CCK-2657.0-1-24

PAV H A104 Pathology Expansion

ADDENDUM # 1

1/24/2024

1 FIRE PROTECTION PLAN  
Scale: 1/4"=1'-0"

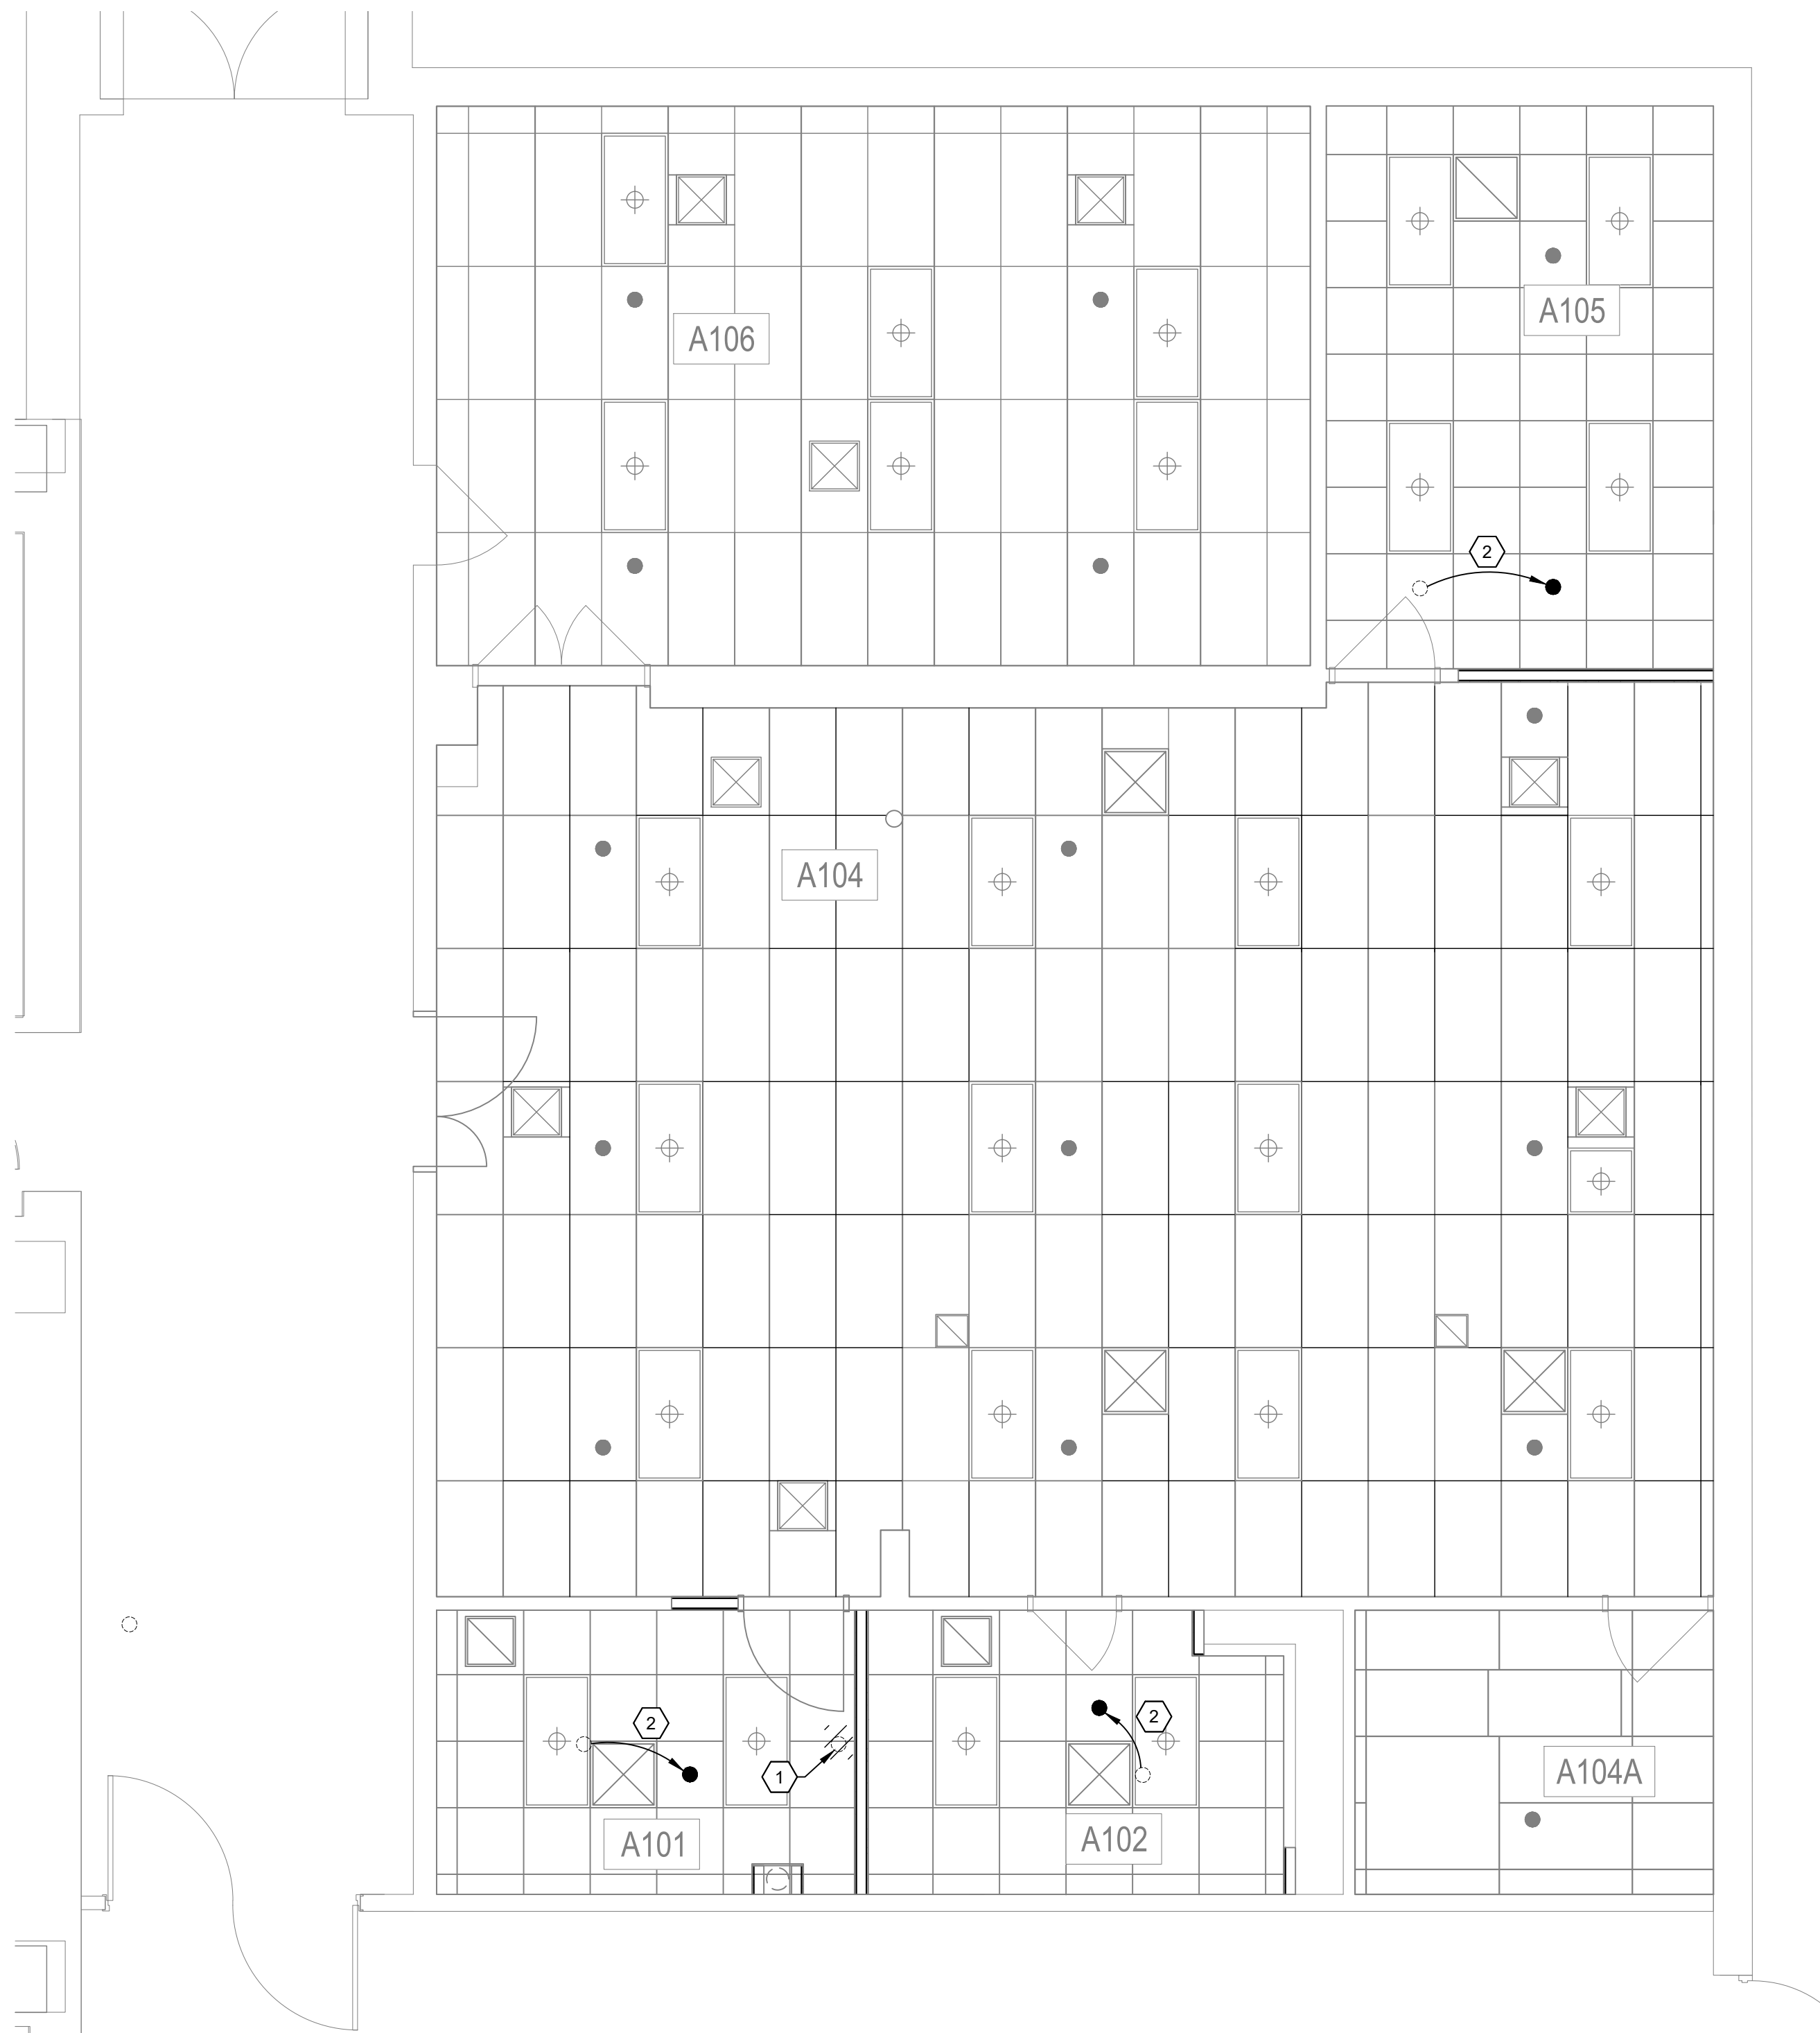
- SHEET NOTES:** (X)
- REMOVE EXISTING PENDENT SPRINKLER. DEMO EXISTING FIRE PROTECTION PIPE BACK TO MAIN CONNECTION AND CAP REMAINING PIPE.
  - RELOCATE EXISTING PENDENT SPRINKLER TO CENTER OF NEW CEILING TILE.
